**CITY OF MERIDIAN
FINDINGS OF FACT, CONCLUSIONS OF LAW
AND DECISION & ORDER**

Case No(s). H-2024-0043

SUBJECT: H-2024-0043
Newkirk East MDA, PP

A Preliminary Plat and Development Agreement Modification to convert 216 apartments into 95 single-family attached homes on 10.08 acres of land zoned Traditional Neighborhood Residential (TN-R).

I. Block Length Exhibit (date: 7/3/2024)

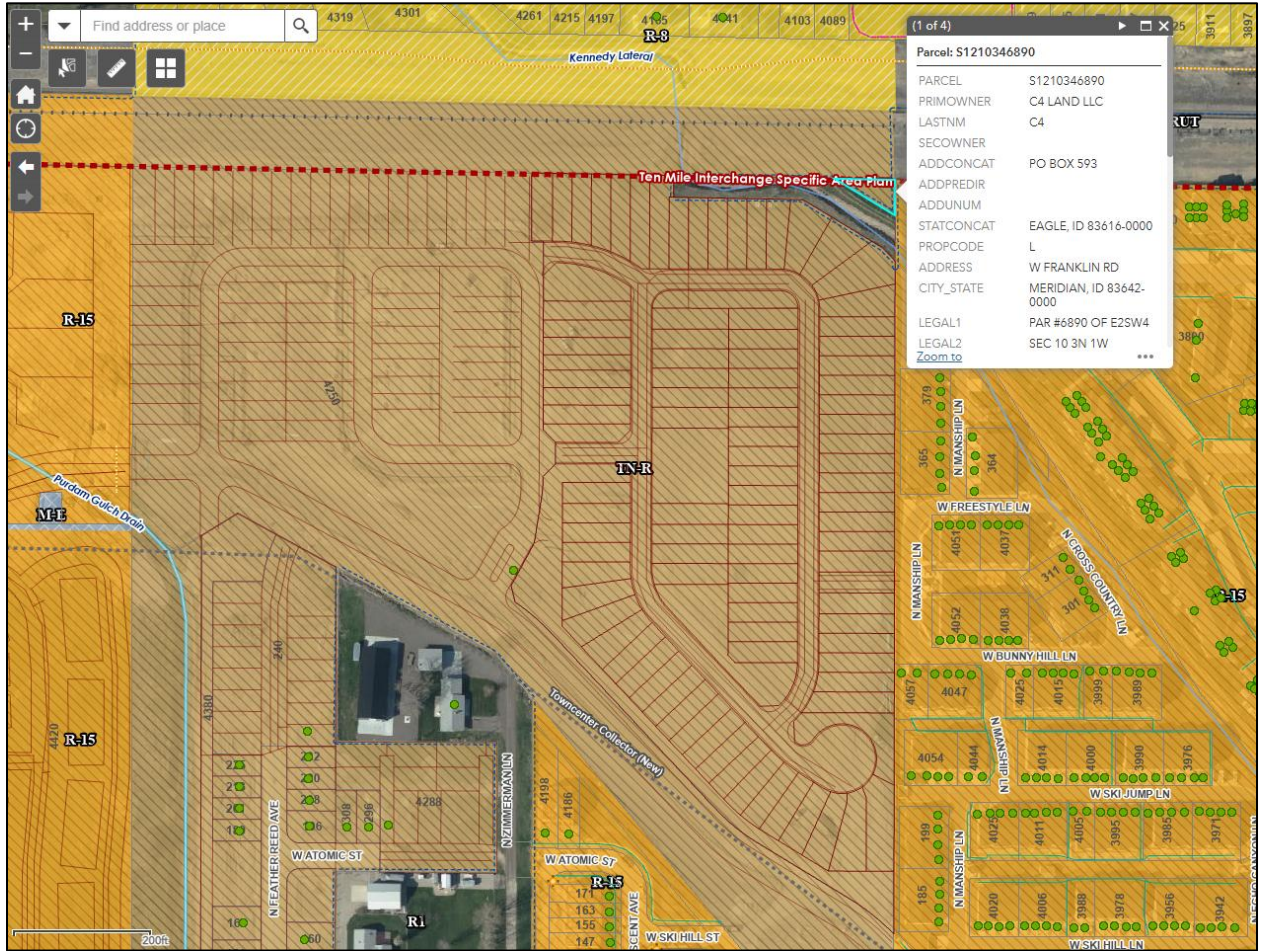
UDC 11-6C-3- regulates block lengths for residential subdivisions. Staff has reviewed the submitted plat for conformance with these regulations. In the TN-C and TN-R districts, no block face shall be more than five hundred (500) feet in length without an intersecting street or alley, except as allowed in subsection (F)(3). Subsection (F)(3) states where a pedestrian connection is provided, the maximum block face may be extended up to seven hundred fifty (750) feet in length in the TN-R District.

The applicant has several blocks lengths that exceed the 500 feet which need to be shorten or justification needs to be provided as to why they cannot meet the requirement. The applicant has provided an emergency access to N. Manship Lane within the Entrata Farms Subdivision No. 2, which counts towards a break in the block length on the east side of the roadway. The applicant can provide access to the open space area along N. Ascent Avenue from N. Wolfsburg Avenue to break up the block length on the west side of the road. Revise the plat map to bring the block length along A. Wolfsburg Avenue into compliance by adding a pedestrian facility along Block 3, in the vicinity of lots 20-23 to connect to the common lot on Lot 3, Block 3.

- Revise the plat map to bring the block length along A. Wolfsburg Avenue into compliance by adding a pedestrian facility along Block 3, in the vicinity of lots 20-23 to connect to the common lot on Lot 3, Block 3.
